**PROJECT ANTEA  
ROAD SAFETY ASSESSMENT  
STUDY**

JOB NUMBER: AV 3049		DOCUMENT REF.: Road Safety Assessment Study Report _ Rev. 1				
1	Final	G. Nellas	K. Souflis	K. Rontiris	K. Rontiris	18.12.07
0	First Issue	G. Nellas	K. Souflis	K. Rontiris	K. Rontiris	24.12.07
		Originated	Checked	Reviewed	Authorised	Date
Revision	Purpose Description	ATKINS

The Atkins Highways and Transportation Team in Athens, Greece, was commissioned by ANTEA CEMENT S.A. Company to undertake a Safety Audit for the proposed roads (a) between the Titan Cement Plant Site and the National Highway Fushe Kruje – Lezhe (NH-PS Road) and (b) between the Flysch Quarry and the Cement Plant Site (FQ-PS Road).

**Figure 3** Location of the Cemetery and Pilgrimage Sites

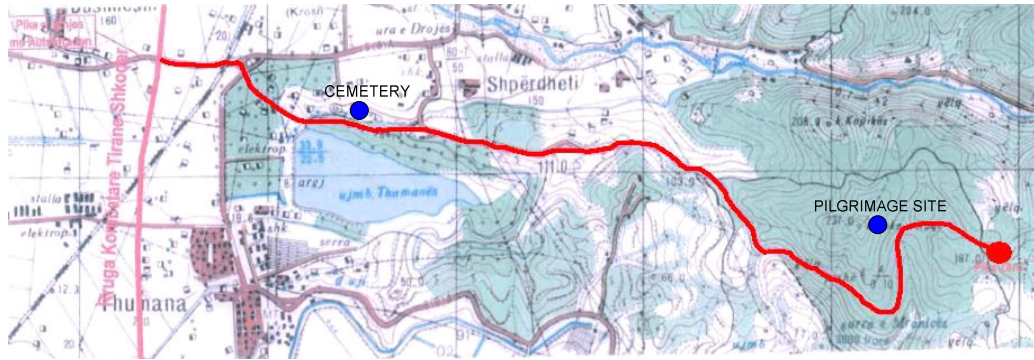
Location: Along the road and especially at intersections and major access / egress locations such as the cemetery and the pilgrimage site (chainage 1+050 and 5+230). These are shown in the following Figure 3.

**Summary:** No pedestrian facilities are shown on the drawings. This could result to unsafe pedestrian conditions especially since the road is expected to carry high volumes of HGV. The associated LoR is considered to be high.

**Recommendation:** Design and provide pedestrian facilities at locations 1+050 and 5+230.
